Diablo Canyon Units 1 and 2

Response to NRC Request for Additional Information Regarding PG&E Letter DCL-11-072, "License Amendment Request 11-06, Revision to Technical Specification 3.3.5, 'Loss of Power (LOP) Diesel Generator (DG) Start Instrumentation" dated October 24, 2011

***PG&E Response to NRC Request for Additional Information for  
Diablo Canyon Power Plant Regarding Technical Specification 3.3.5***

Enclosure  
Attachment 2  
PG&E Letter DCL-12-038

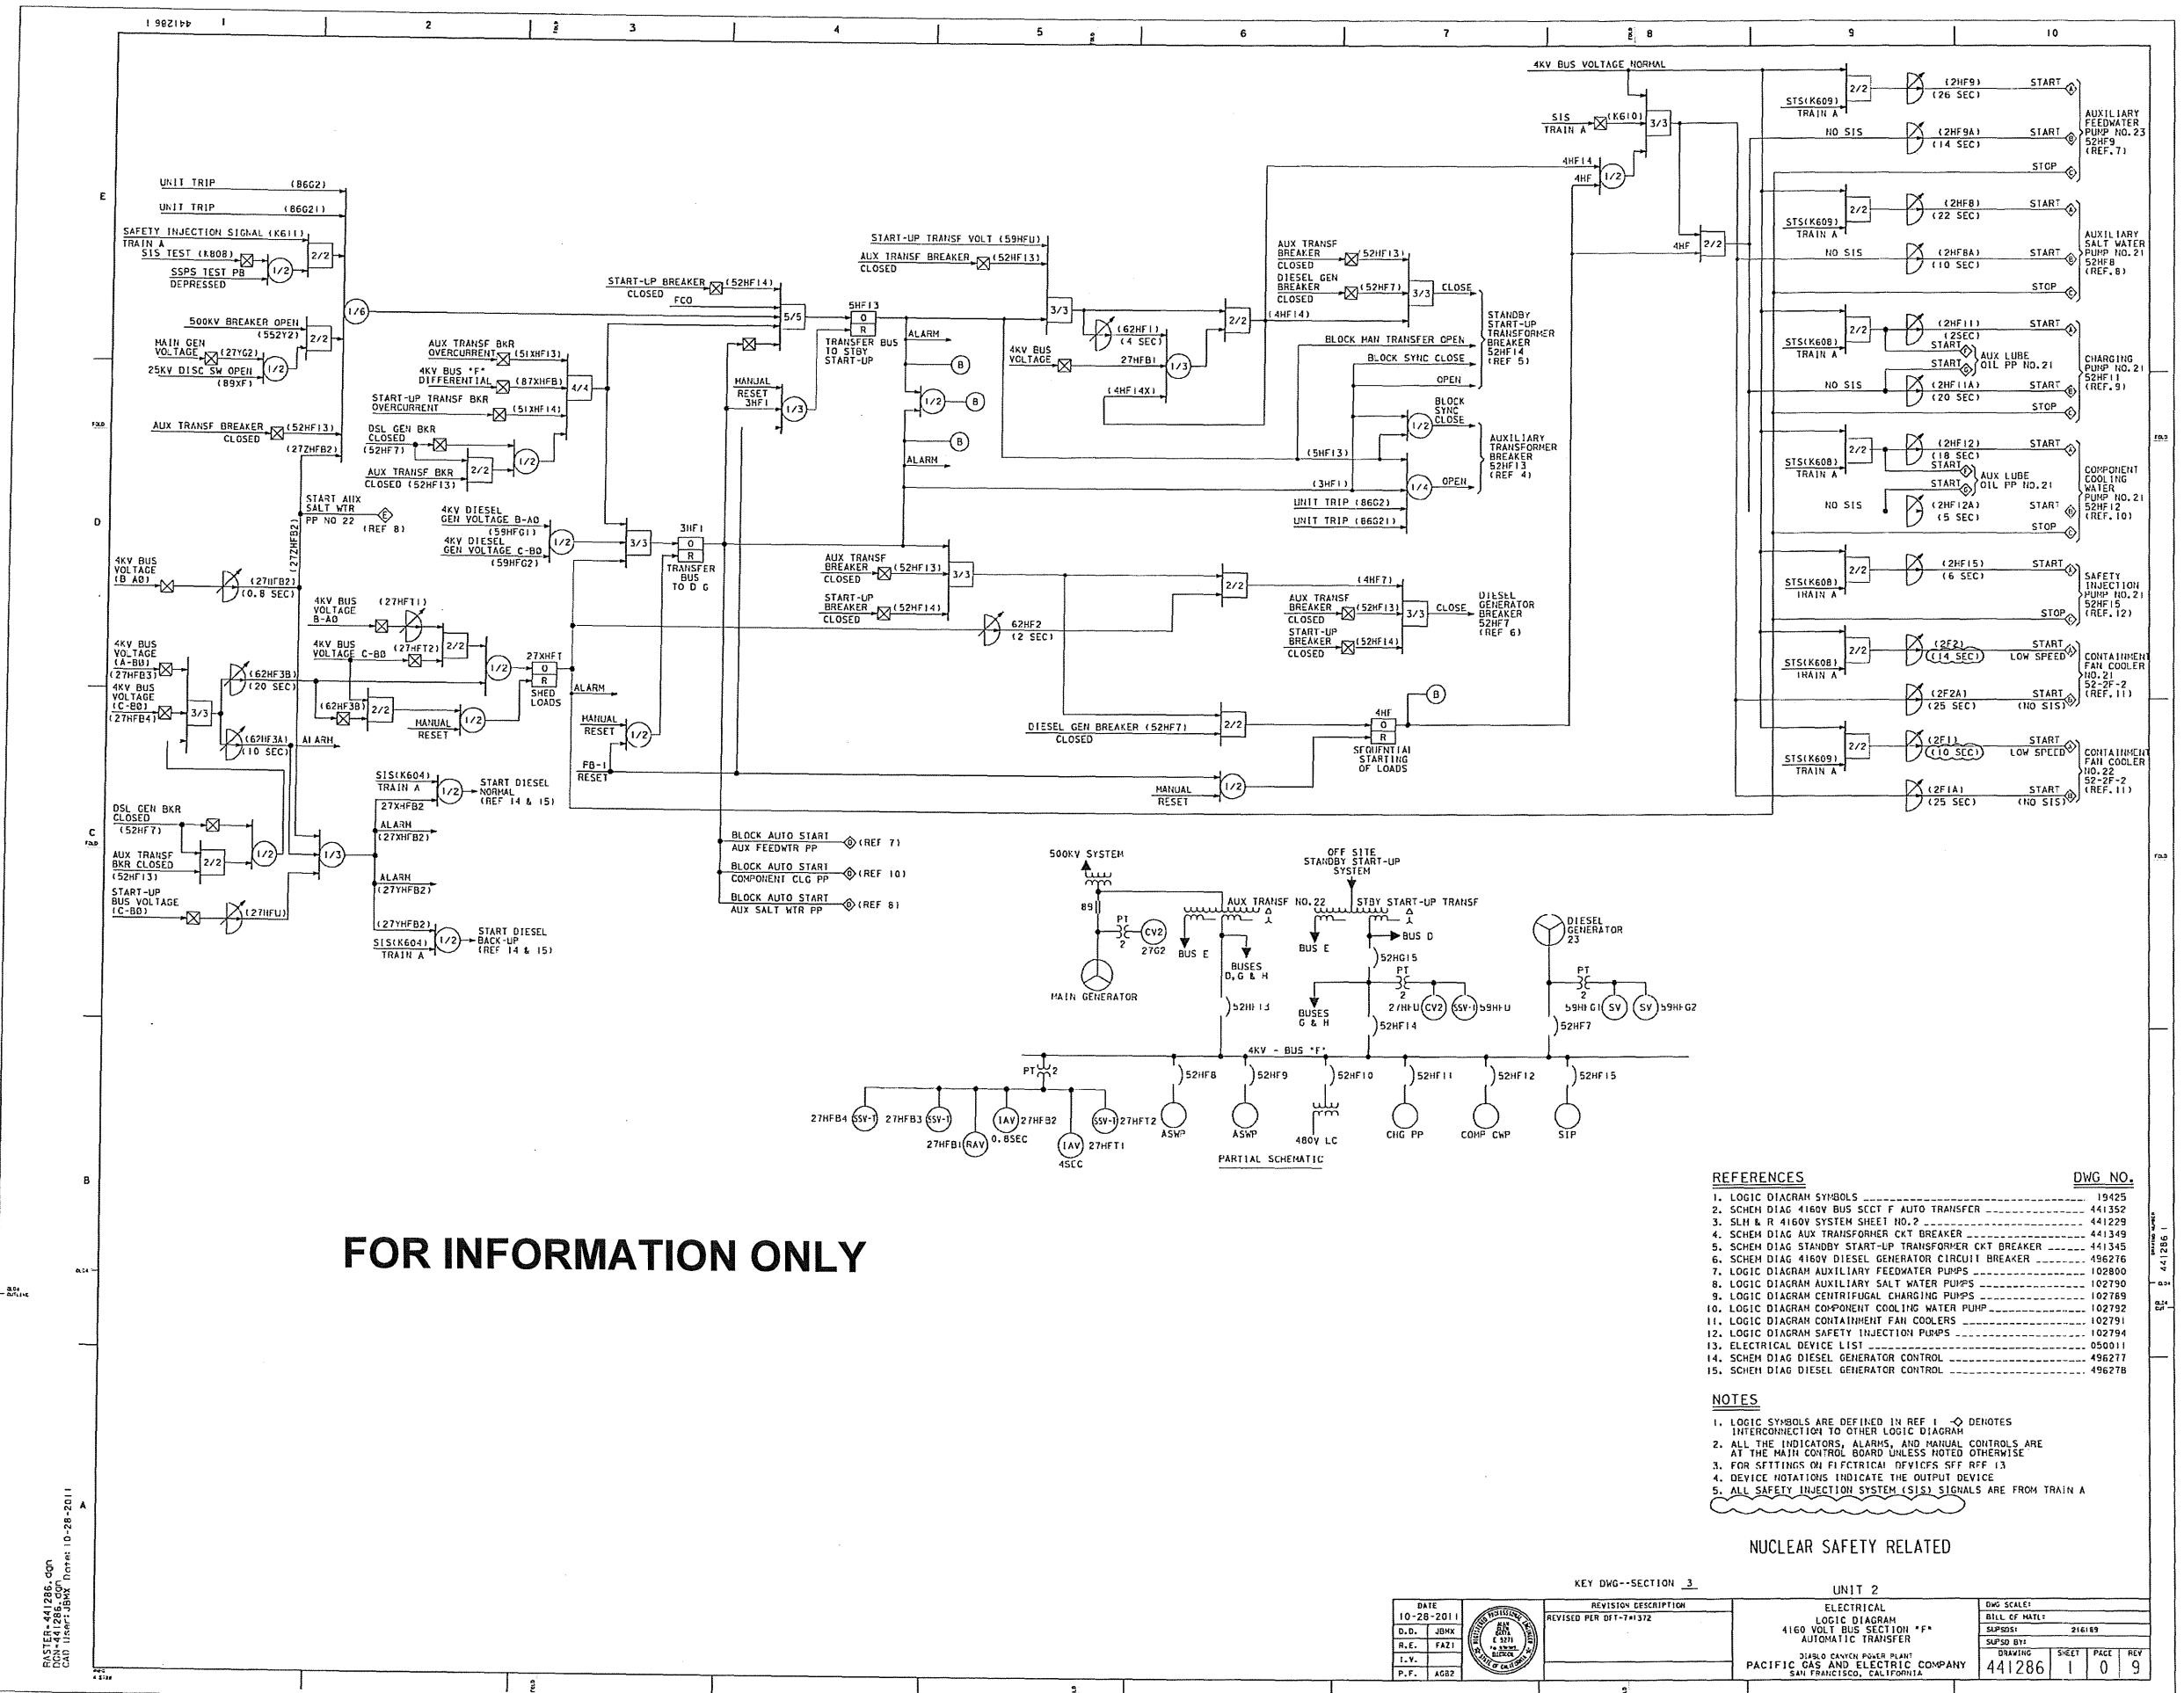
*Please provide diagrams indicating how the different devices described above are connected including the connection of the potential transformers and the relays, to enable the staff to understand the justifications requested above. Indicate what combination of relays are required to ensure that the required protective action is successfully achieved.*

Informational logic diagrams, schematics and connection diagrams are attached to this submittal as listed below. Drawings are stamped "PRELIMINARY FOR INFORMATION ONLY" as the design change to implement the new protective logic is still in the development phase. However the following is not expected to change: logic, coincidence, permissive design, and relay connection.

Reference page 2 of Attachment 1, PG&E Drawing 441286, for the following explanation of required relays for protective function. Under the new protective logic design for degraded bus voltage conditions, where bus voltage is less than 80 percent of nominal, the protective load shed function is initiated by the First Level Undervoltage Relays. A combination of either of the three 27HxT1y relays (where x designates the bus "F," "G," or "H" and y designates the degraded voltage level "A," "B," or "C") and the 27HxT2 instantaneous relay are required for initiating the load shed protective function for the respective bus. At degraded voltages between 80 percent of nominal and 91 percent of nominal, the protective load shed function is initiated by the Second Level Undervoltage Relays and remains unchanged from previous design. A two out of two coincident pick-up of the 27HxB3 and 27HxB4 Relays in combination with a timeout of the 62Hx3B Timer Relay is required for initiating the load shed protective function for each bus.
